SCENARIO 2B LAYOUT

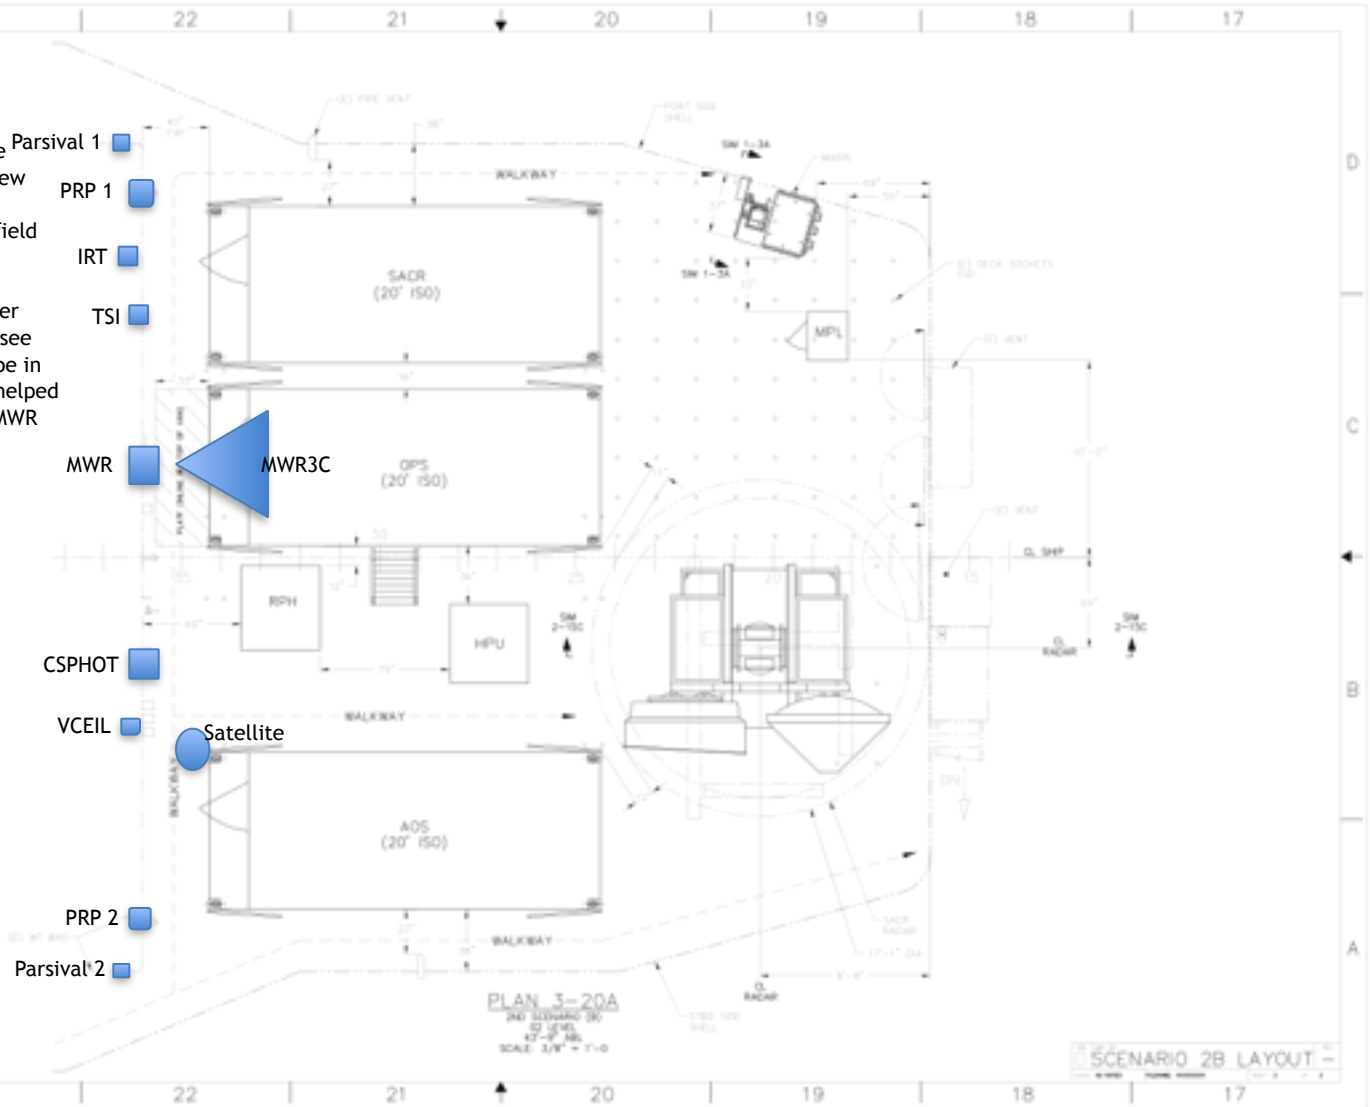
Near Parsival 1 is ship ORG.
 We may need to adjust location
 At time of deployment. Want to
 Include a few extra feet of cable.
 IRT mounted below top rail as is the
 VCEIL. These won't be in field of view
 Of other instruments.
 TSI, MWR and CSPHOT could block field
 Of view of one another so trying to
 Spread apart as much as possible.
 Parsivals can be mounted to be lower
 Than PRP so the radiometers don't see
 Them. AOS stack and satellite will be in
 Field of view of PRP2 but can't be helped
 MWR3C will be slightly lower than MWR
